NHS-0000-99 (247)

Interchange Improvements at Roswell Road and Interstate 285

Value Engineering Study Report

Concept Design Stage July 2004

RW-6

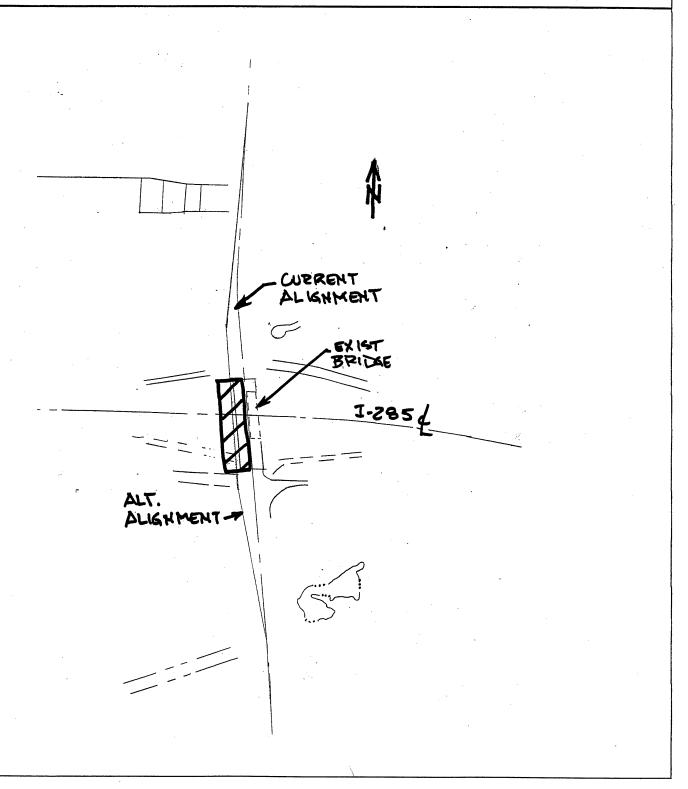
This alternative will realign the proposed Roswell Road farther to the west. The intent is to eliminate any right-of-way acquisition or easements. The current alignment, even though it does not show much right-of-way acquisition on the eastside, would require some due to bike lanes, curb and gutter, and improved/wider sidewalks. While not requiring total acquisitions on the eastside, it would affect the businesses to a significant degree, especially in terms of parking, and therefore will be costly, disruptive, and time consuming. Additionally, the toe of the slope looks as if it is encroaching the lake in the southeast quadrant, which is certainly undesirable. The shift in Roswell Road farther west will eliminate or minimize any detrimental effects to the eastside and right-of-way acquisition.

RW-10

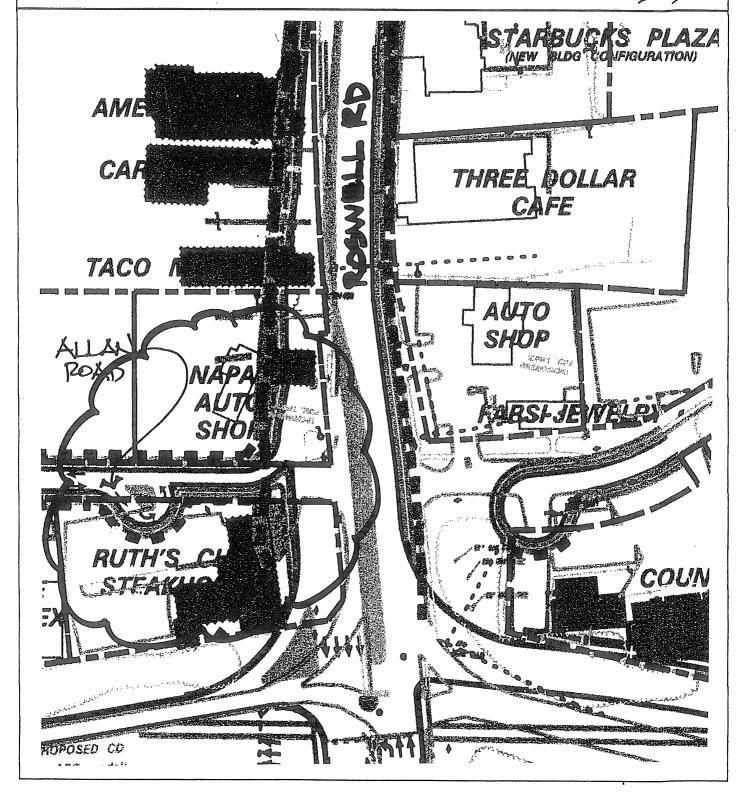
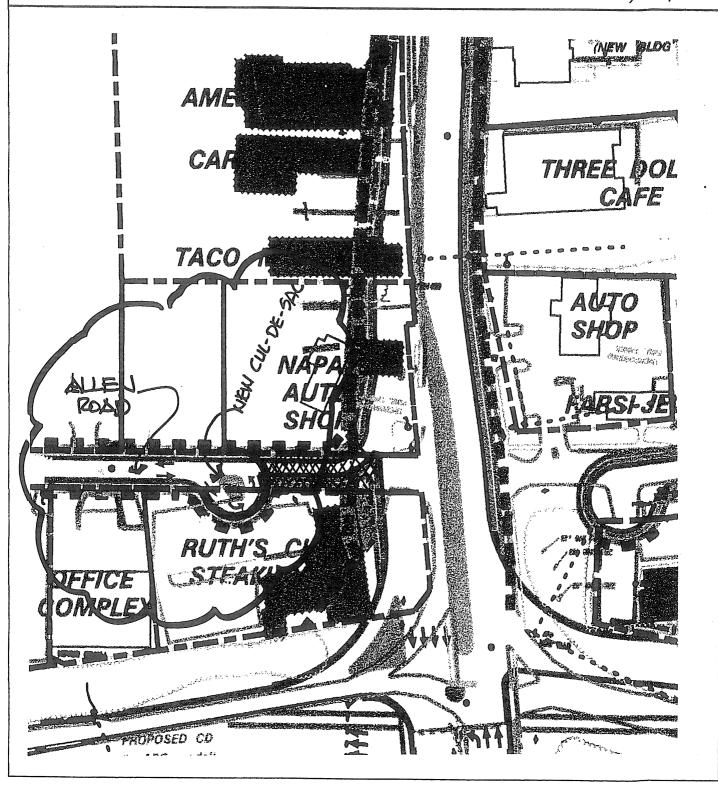
The access to and from Allen Road appears to be in violation of limited access criteria to interstate ramps and does not add much benefit to the project. It actually presents a more dangerous condition by having a side road close to a ramp turn-off. Access to Allen Road is provided by Cliftwood Drive and Sandy Springs Circle and is not required as shown on the current concept. If emergency vehicle access is a concern, other provisions can be provided. Eliminating the Allen Road access from Roswell Road will provide a safer alternative that conforms to current established standards.

ALTERNATIVE NO.:

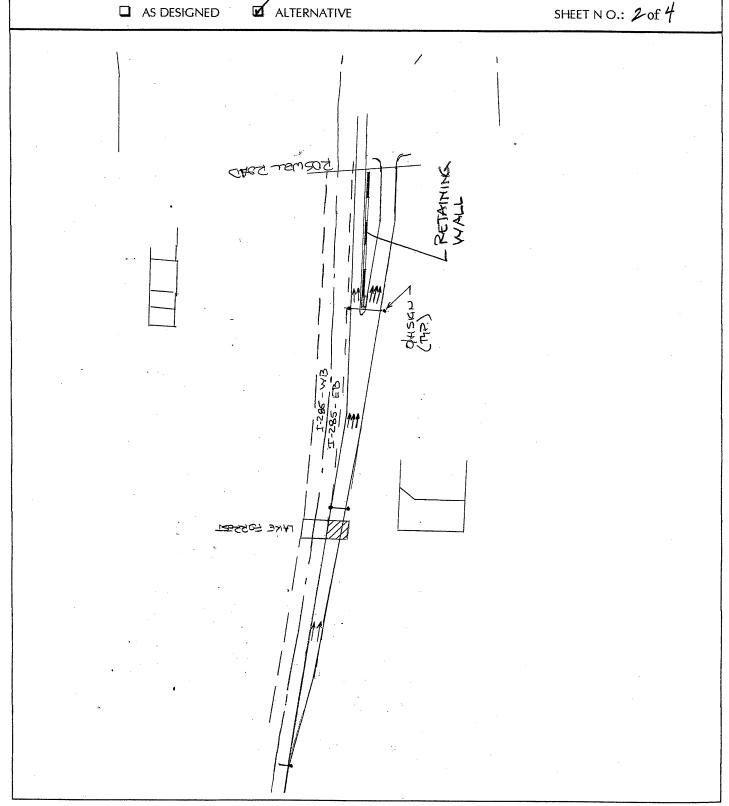
Provide separate eastbound (EB) exit ramps from I-285 for Roswell Road and Glenridge Drive.

Additionally, a longer ramp would provide more vehicle storage, improving Roswell Road intersection movements. The distance of the ramp's movement will need to be evaluated for traffic conflicts farther west at the previous interchange—Riverside Road. Also, it would allow for additional right-of-way purchases to facilitate future improvements.

R-10

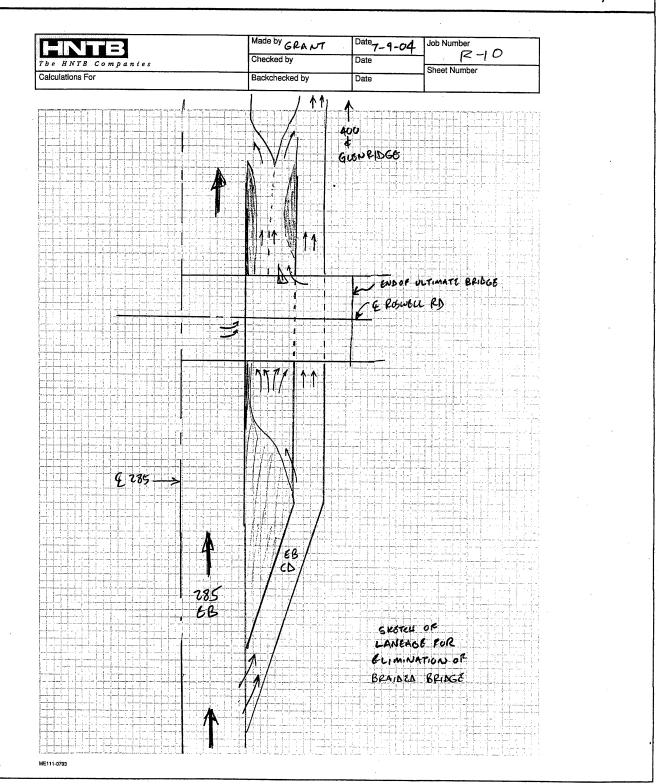
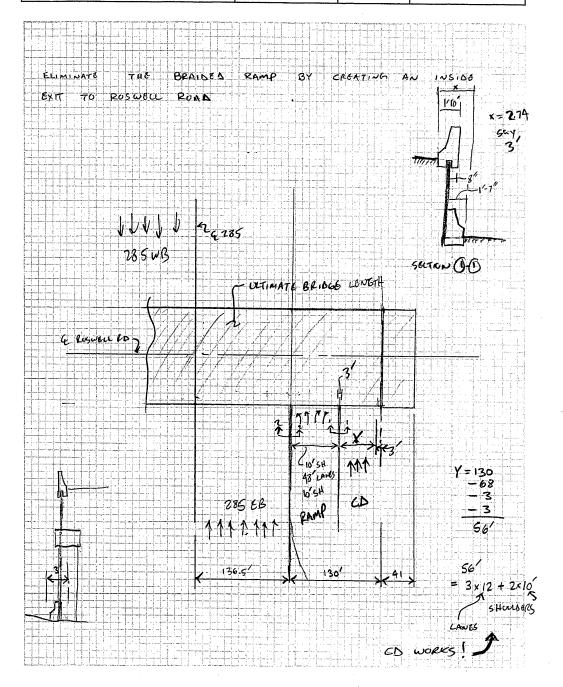
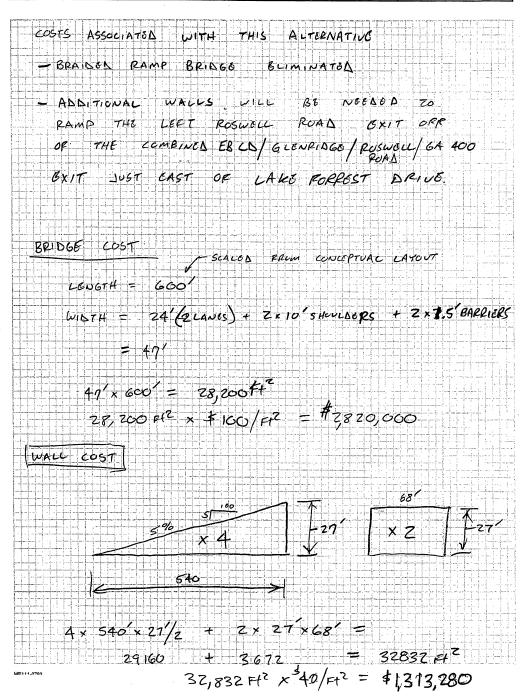
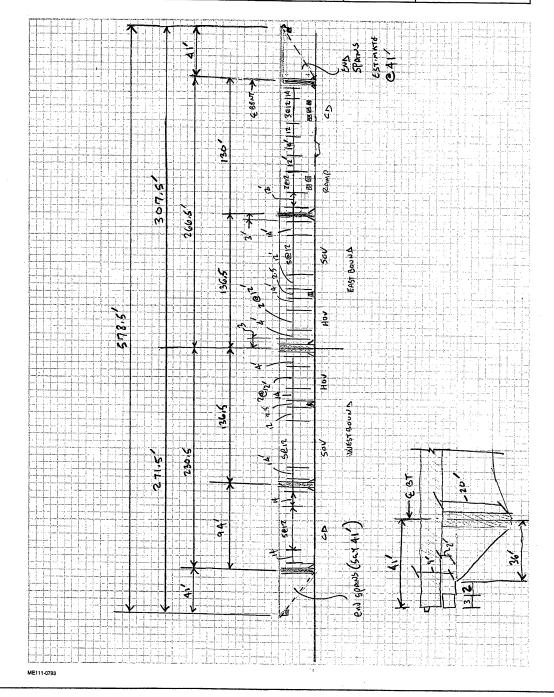
The location and layout of the braided ramp should be studied more closely to provide the safest, most economical alternative available. During the presentation, the presenter noted that not much effort was spent in developing the vertical alignment or the continuation of the Glenridge/SR 400 exit ramp.

Another alternative investigated is combining the Roswell Road and Glenridge Drive/SR 400 ramps into one exit ramp from I-285. A sketch is included. This will provide the benefits of eliminating the two exit ramps off I-285, although it will require the decision point on the ramp. It will also require additional retaining walls to support the Roswell Road ramp. However, it will eliminate any new structure required for the braid. It should also fit within the alignment of the maximum, ultimate bridge width.

The Glenridge Drive/SR 400 part of the ramp would continue under the Roswell Road bridge and the ramp to Roswell Road would peel off and continue up to Roswell Road.

R-16

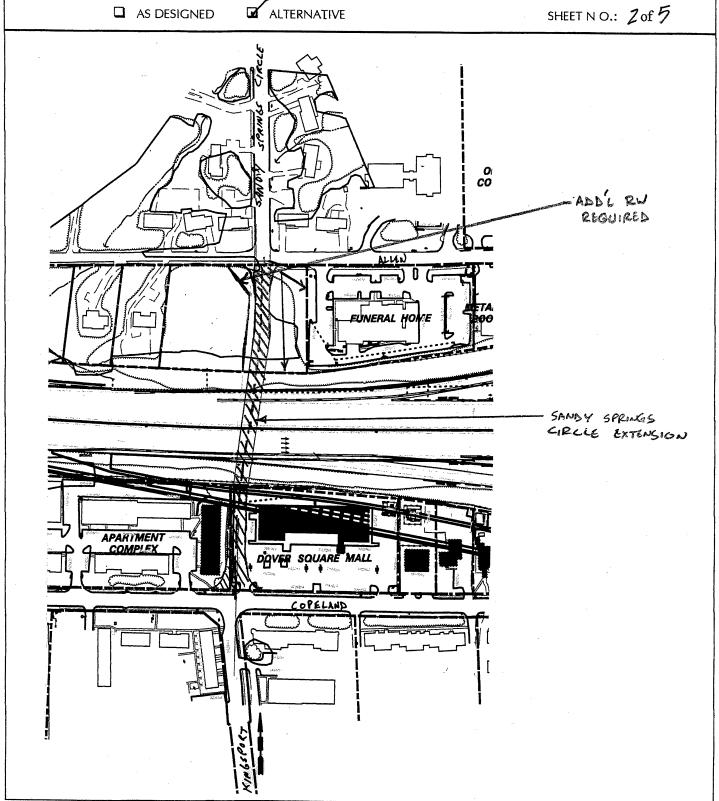
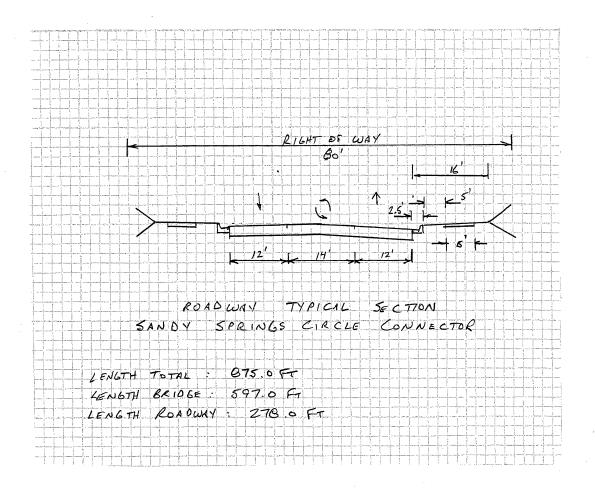
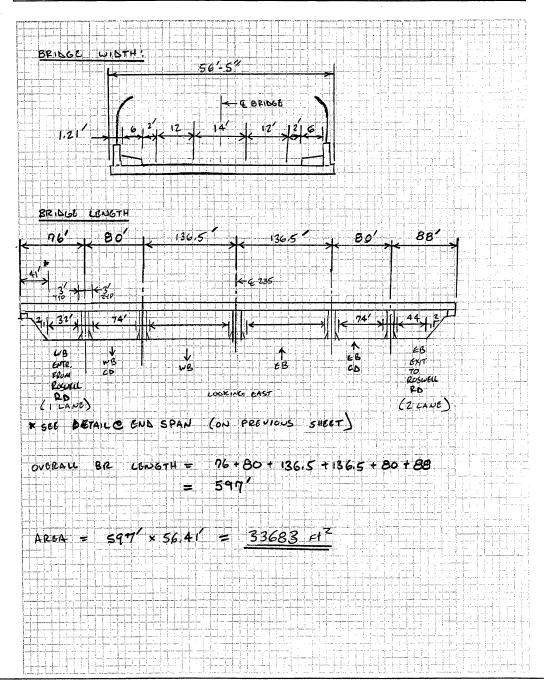
Provide a bridge to connect Sandy Springs Circle with Copeland Road for local traffic to cross I-285.

This alternative may relieve local traffic off Roswell Road in the vicinity of the interchange and provide an alternate route in emergencies.
